AGENDA
DHCD Workgroup #3
September 27, 2012 - 9:30 a.m. - 3:30 p.m.

DHCD Workgroup #3 2012 USBC International Residential Code June 14, 2012 - 9:30 a.m. - 3:30 p.m.

Code Change Form for the 2012 Code Change Cycle

FIGURE R602.13(1)
EMPIRICAL METHOD EXTERIOR WALL CONSTRUCTION

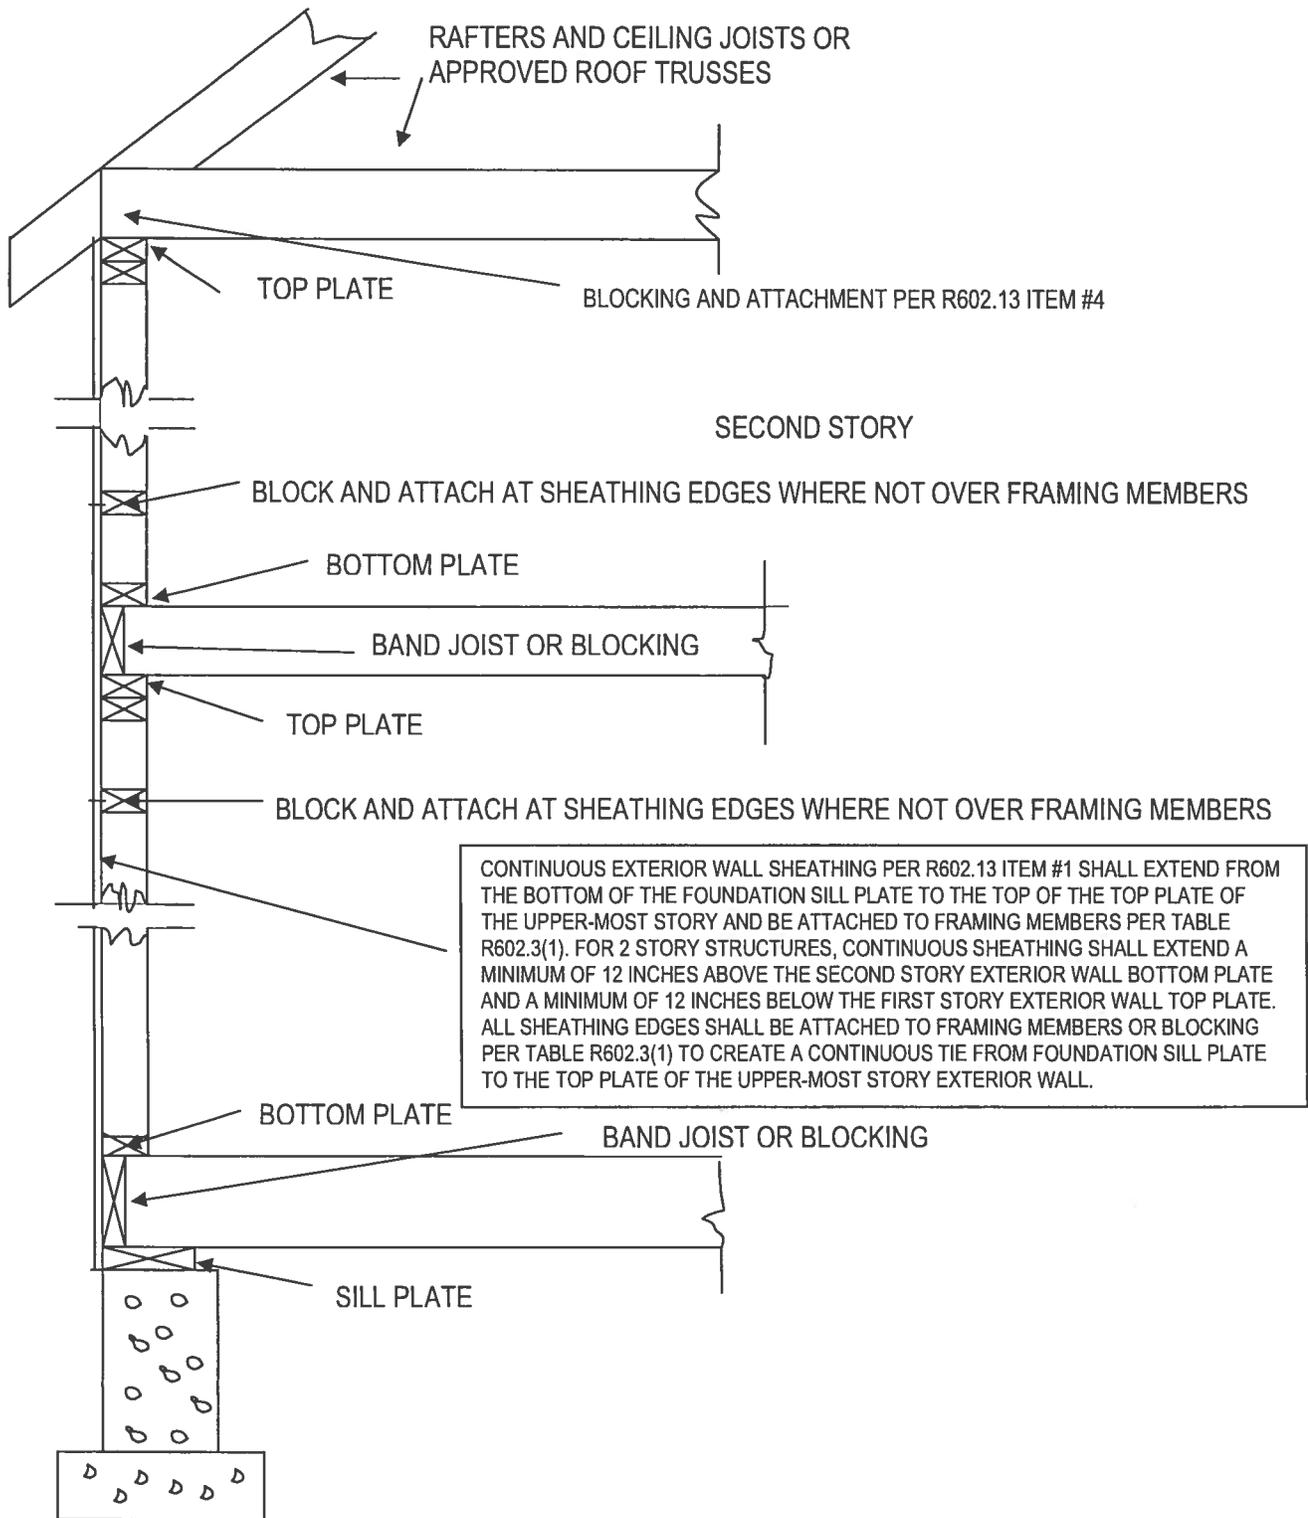
R602.13 Empirical method. Buildings having a maximum height of 2 stories above grade, a maximum roof framing span of 32 feet, a maximum total floor area, excluding basements, of 3,000 square feet, located in seismic design category A, B, or C, in an area where the basic wind speed is less than 110 mph, shall be permitted to be constructed in accordance with the following:

2. foundation sills shall be anchored to concrete or masonry foundations in accordance with Sections R403.1.6 and R602.11.1, and
3. exterior walls shall be constructed in accordance with Figure R602.13(1), and

FIGURE R602.13(2)

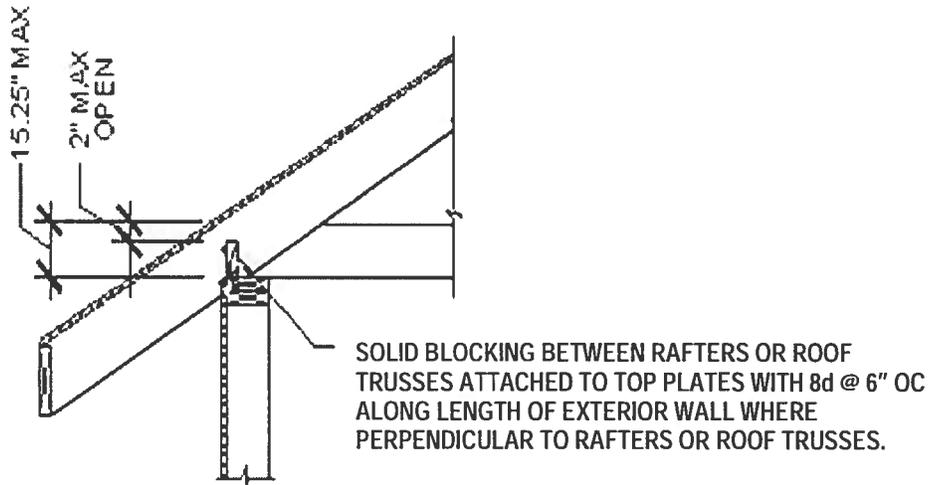
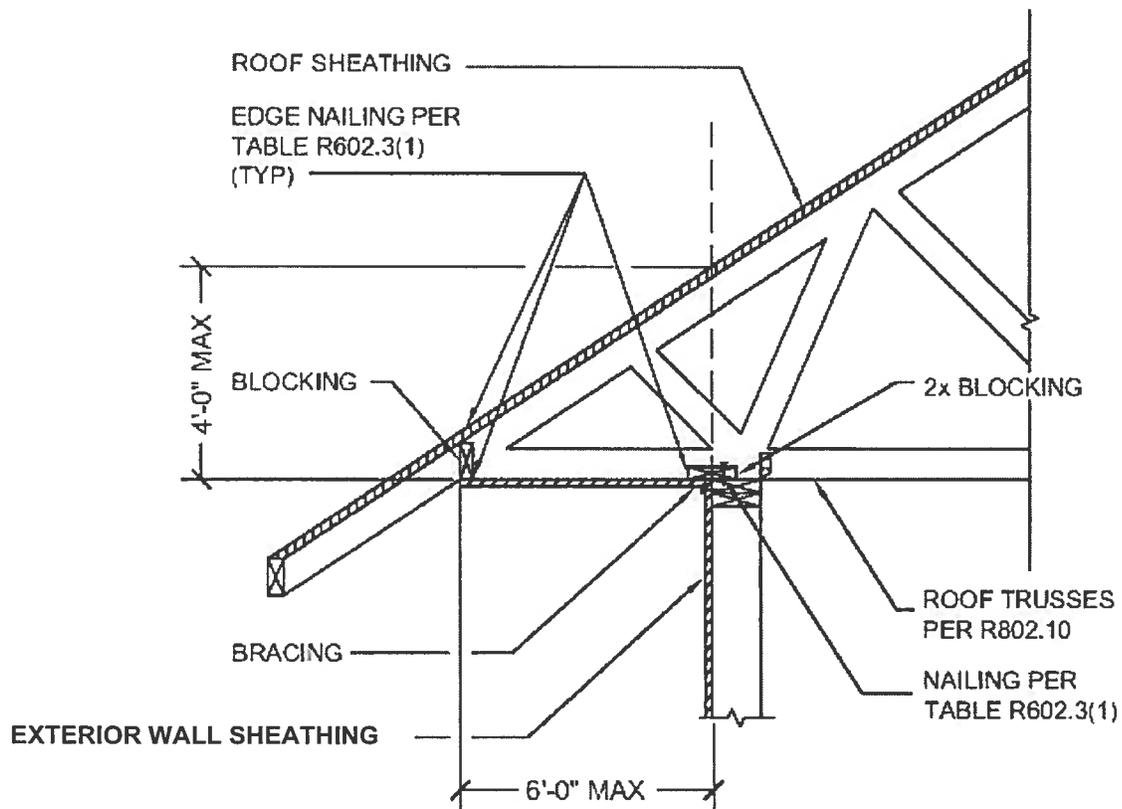
- ii. Where the distance from the top of the exterior wall to the top of the rafters or roof trusses above is between 9.25 inches (235 mm) and 15.25 inches (387 mm) blocking between rafters or roof trusses shall be provided in accordance with Figure R602.13(2).

- B. For wind speeds of 100 mph (45 m/s) and less than 110 mph (49 m/s), where the distance from the top of the exterior wall to the top of the rafters or roof trusses above is 15.25 inches (387 mm) or less, blocking between rafters or roof trusses shall be provided above the exterior wall in accordance with Figure R 613.(2).

FIGURE R602.13(3)
EXTERIOR WALL CONNECTION OPTION TO PERPENDICULAR RAFTERS OR ROOF TRUSSES

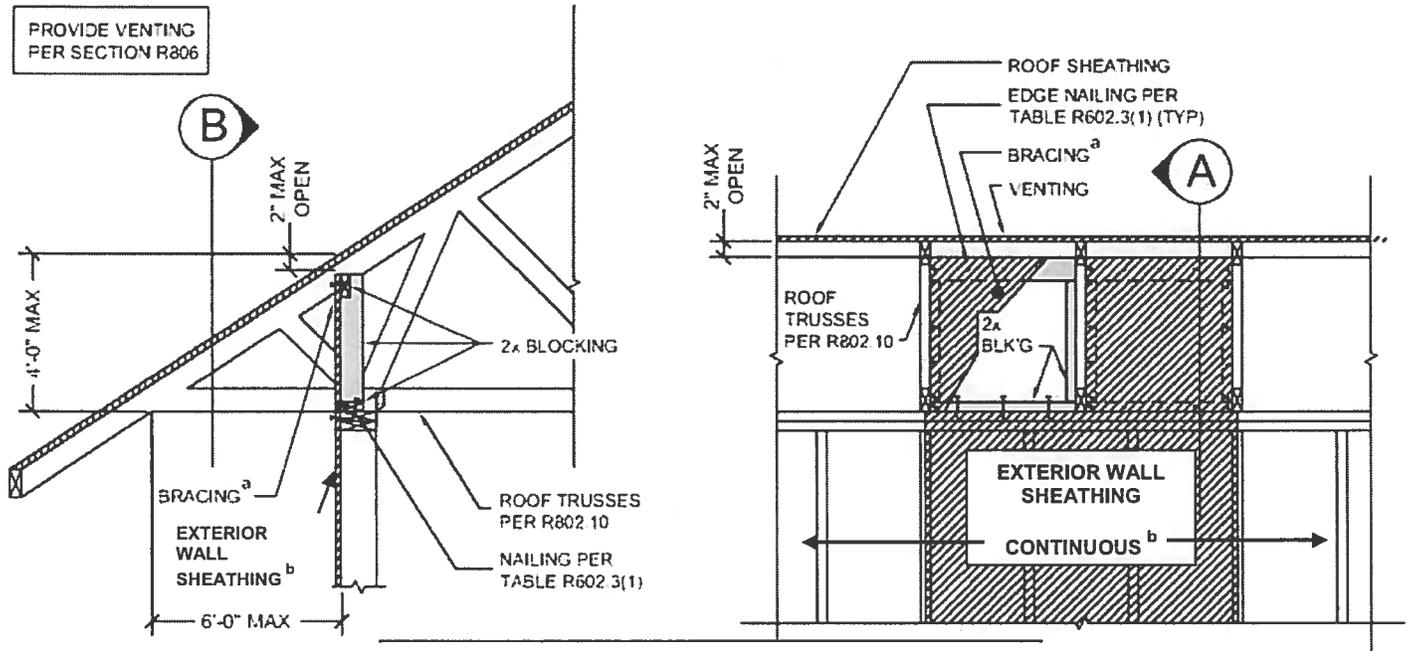
- i. Soffit blocking panels constructed per Figure R602.13(3).
 - ii. Vertical blocking panels constructed per Figure R602.13(4).
 - iii. Full-height engineered blocking panels designed per the AF&PA WFCM.

- a. Bracing shall be minimum 7/16 inch wood structural panels fastened in accordance with Table R602.3(3), or minimum 1/2 inch structural fiberboard sheathing fastened in accordance with Table R602.3(1), either or both, and shall be continuous at all locations where rafters or roof trusses are perpendicular to exterior wall.
- b. Exterior wall sheathing shall be minimum 7/16 inch wood structural panels fastened in accordance with Table R602.3(3), or minimum 1/2 inch structural fiberboard sheathing fastened in accordance with Table R602.3(1), either or both, and shall be continuous for the entire perimeter except at openings.

R507 Decks

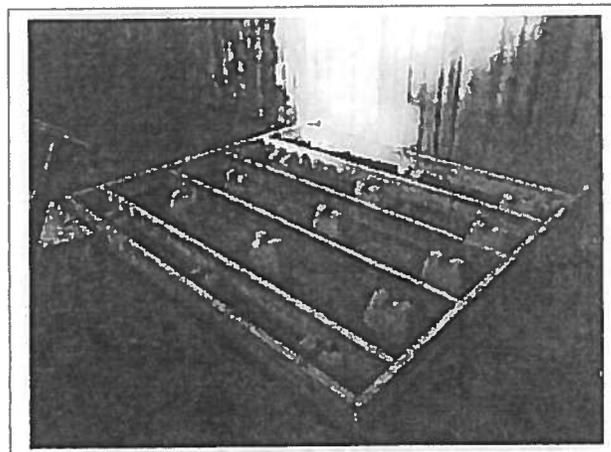
Allow concrete pier blocks to be used for wood decks.

Condition: Free standing decks.
